MONTGOMERY COUNTY HISTORIC PRESERVATION COMMISSION
STAFF REPORT

Address:	15 Columbia Ave., Takoma Park	Meeting Date:	7/14/2021
Resource:	Non-Contributing Resource Takoma Park Historic District	Report Date:	7/7/2021
Applicant:	Jeff Dorn Wakako Tokunaga, Architect	Public Notice:	6/30/2021
Review:	HAWP	Tax Credit:	n/a
Case No.:	952481	Staff:	Dan Bruechert
Proposal:	Building Alterations, Rear Addition, Hardscape Alteration, and Accessory Structure Construction

Figure 1: 15 Columbia Ave., Takoma Park

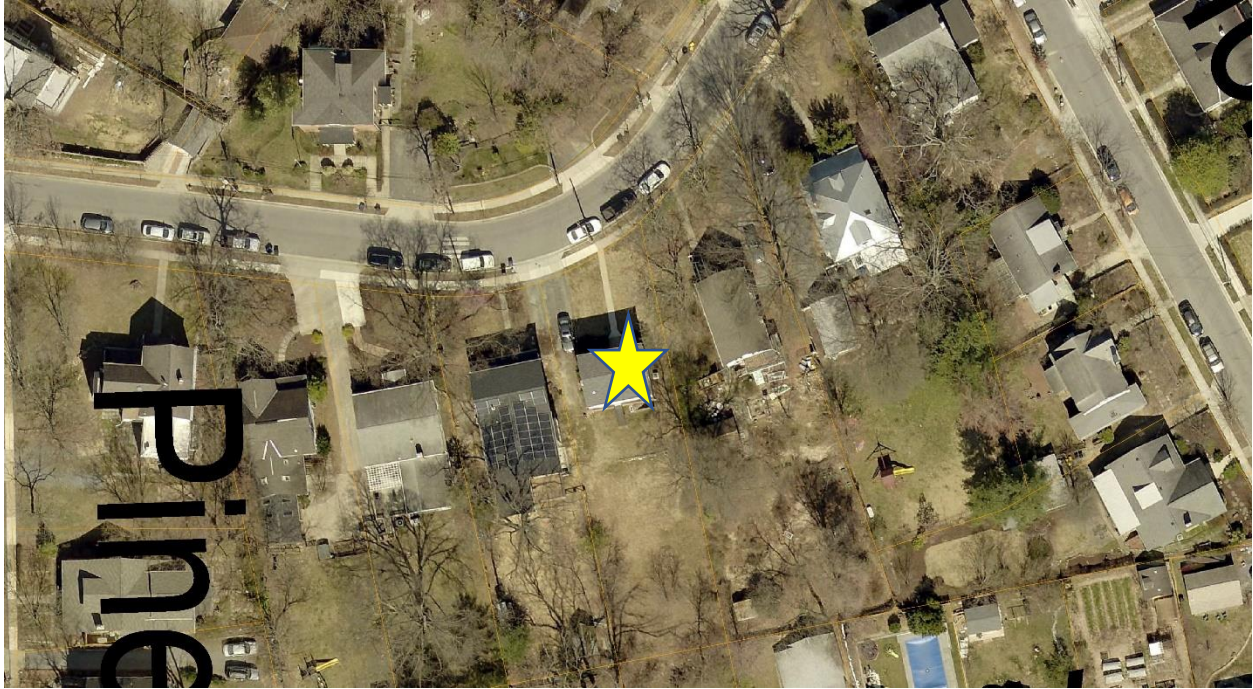
Staff finds that all of these changes are consistent with the *Design Guidelines*, as they will not change the size or massing of the existing Non-Contributing Resource. Based on a lenient review, Staff recommends the HPC approve the changes to the existing house.
